**External Envelope:
Glazing, Insulated Render and
Stone Façade Elements**

AERCAP HOUSE METROLINK INTERFACE

Aercap House, St. Stephens Green, Dublin

**Document No:
PR-24-018-BDA-XX-ZZ-RP-Y-0001-C01**

Figure 1 Plan of Aercap House with TII predicted ground settlement. Max. settlement is now predicted as 22.14mm

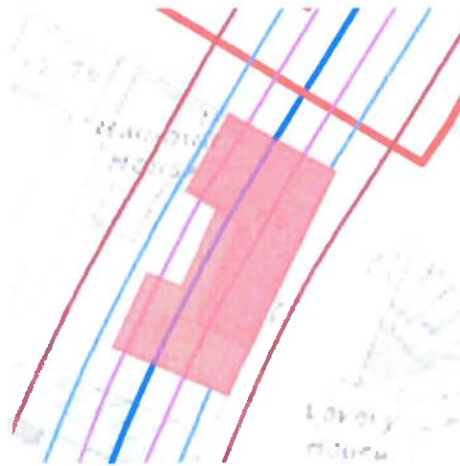
MetroLink has assessed the predicted "Settlement" and presents its findings on drawing no. ML1-JAI- EIA-ROUT-XX-DR-Y-21146 rev P02. This drawing indicates MetroLink will be causing a 10mm settlement directly under the location of our client's building which is unacceptable. We have not received an update of this drawing.

However, the new document 'Addendum to the EIAR – Downward Tunnel Realignment: St Stephen's Green Station to Charlemont Station (P01 06.03.2024)' indicates a revised settlement of maximum 22.14mm. Settlements of this magnitude cannot be accommodated by the building's facades. Such settlement, particularly if introducing differential settlement between columns, will cause damage.

Figure 3 Portland Stone close-up

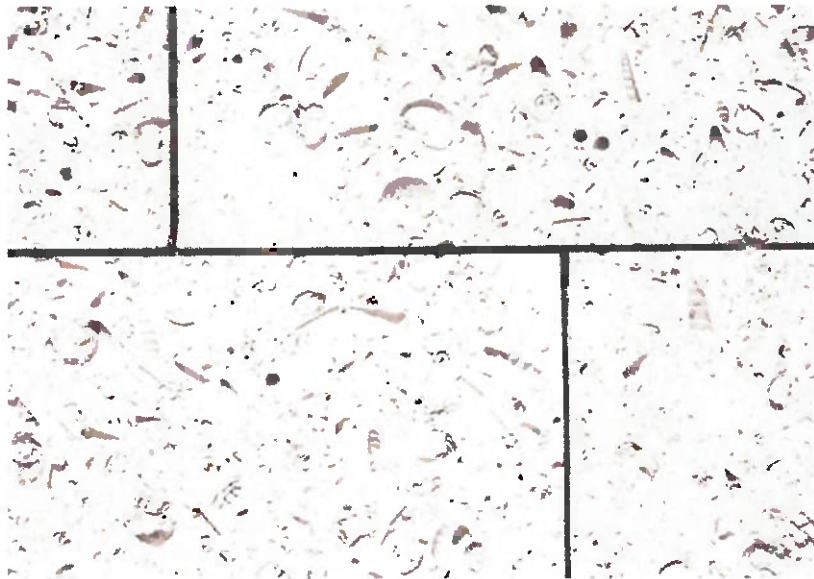
The stone on Aercap House is categorised as a low strength limestone. The stone on Aercap House is 50mm thick supported on stainless steel shelf angles at each floor level. Should the primary structure deform due to tunnelling below the building, there is a likelihood the façade system will suffer damage. Damage can occur due to differential settlement of a column along the elevation. With the current tunnel position as illustrated in Figure 1 above, the highest risk locations for damage to the Portland stone cladding are the North and South elevations.

Figure 4 South elevation. Differential settlement causes rocking of stone piers.

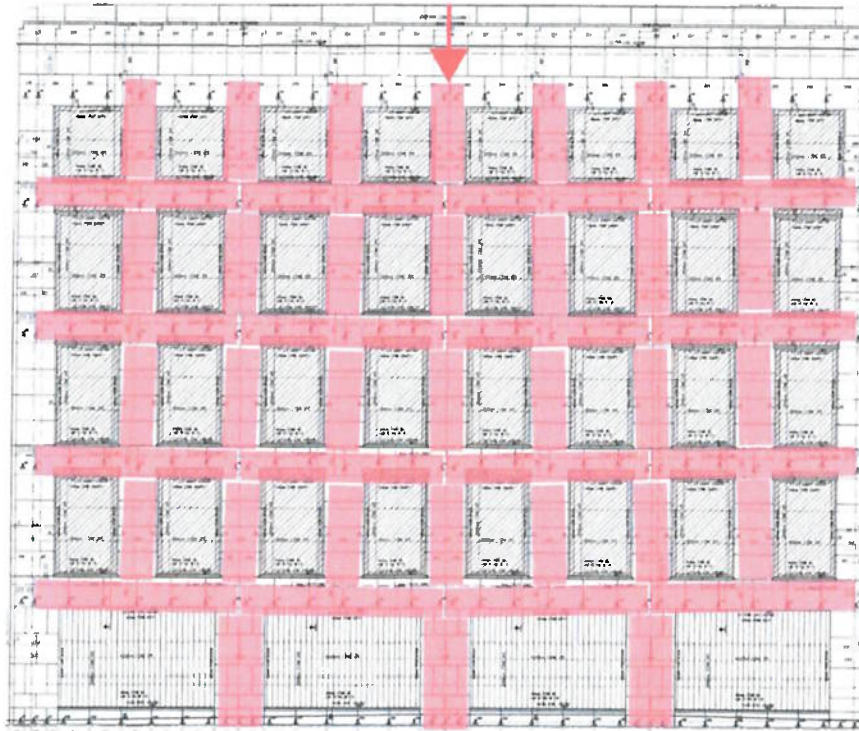
Racking of the stone piers is caused by rotation of the slab as a result of differential settlement between columns. Assuming a 22mm drop along a 12m width (to be confirmed by TII) from centre-line of tunnel to perimeter of settlement, we could expect the base of a stone pier which is 1000mm wide to rotate approximately 1.8mm at its base. Each pier is approximately 3.8m tall. The pier of stone will want to rotate 7.2mm at the top.

As the stone is restrained by local stainless steel rods which can accommodate some bending, the stone is likely to move less than this, but as the structure moves, stress in the stone to fixing interface will increase. The stone to stone joints are open and such racking could result in closing of joints at interfaces with canopies on the South elevation. Stone to stone contact could result in cracking. In worst case scenario, stone could be over-stressed locally, crack and fall.

Figure 7 Timber framed curtain wall. Racking of glass within frame

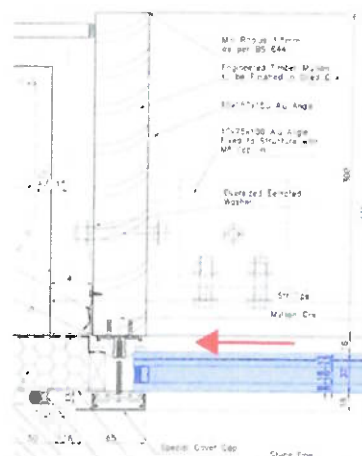
Assuming a 22mm drop along a 12m width (to be confirmed by TII) from centre-line of tunnel to perimeter of settlement, we could expect the base of a typical window which is 1800mm wide to rotate approximately 3.3mm at its base. Each window is approximately 2.8m tall. The glass within the frame will want to rotate approximately 5mm at the top corner. Due to the fact the system is a gasket net, this rotation would result in glass to epdm profile contact rather than glass to metal contact.

However, as the inner glass is 12.8mm laminated annealed glass, it is susceptible to edge damage and has very limited capacity for edge stress. As a result, there is a risk of the inner glass cracking.

Figure 8 Plan view of North elevation ground level glazing

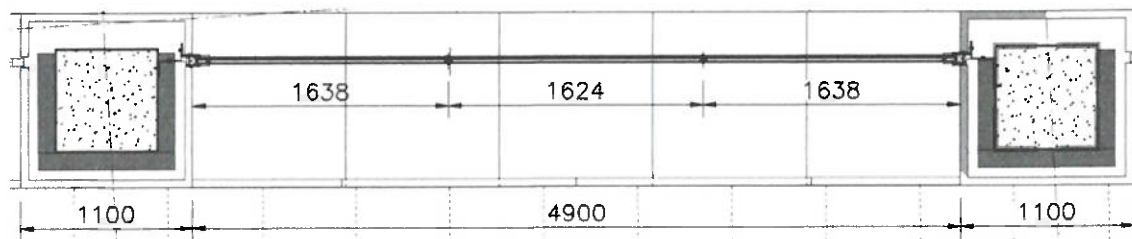
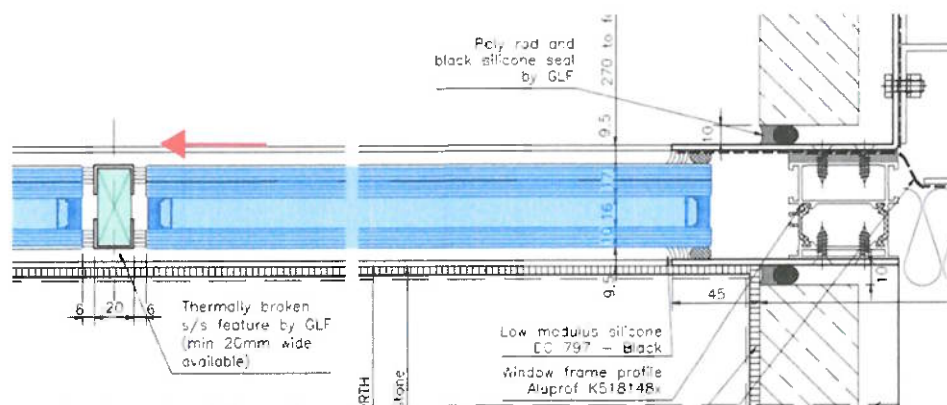
The ground level glazing to the North elevation will suffer racking due to the predicted ground settlement. The individual panels of glass are approximately 1.6m wide and 2.9m tall. They are free spanning from floor to ceiling.

Assuming a 22mm drop along a 12m width (to be confirmed by TII) from centre-line of tunnel to perimeter of settlement, we could expect the base of a typical glass panel which is 1630mm wide to rotate approximately 3mm at its base. Each panel of glass is approximately 2.9m tall. The glass will want to rotate approximately 5.3mm at the top corner. Due to the fact the system is a bespoke shuffle-glazed solution, the perimeter glass at the column should be free to rotate in the channel.

However, as the inner glass is 15.5mm laminated annealed glass, it is susceptible to edge damage and has very limited capacity for edge stress. As a result, there is a risk, although low, of the inner glass cracking where it presses against the the stainless steel clad fin which will be caught between glass panels.

Figure 10 Vertical section through the 70mm thick stone canopy

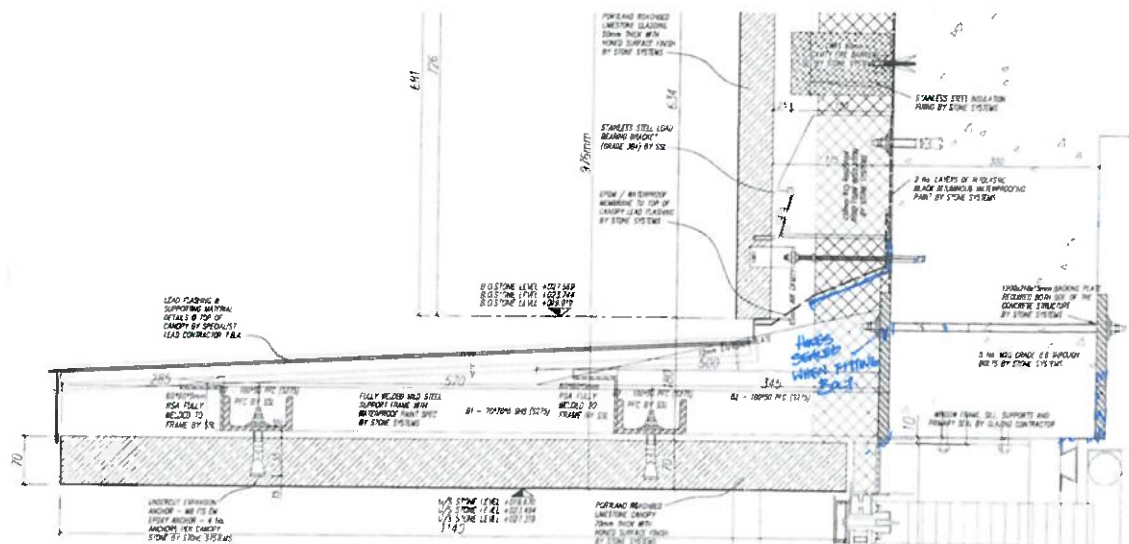
We would recommend careful consideration and monitoring, particularly of the canopies to the South and East elevations. We believe the South elevation will suffer significant vibration during the tunnelling under the building. The canopies are cantilever steel frames with 70mm Portland stone suspended from them. Any loosening of fixings due to vibrations could be hazardous.

We recommend monitoring of each façade prior to tunnelling, during tunnelling and directly afterwards to ascertain any degradation of the systems.
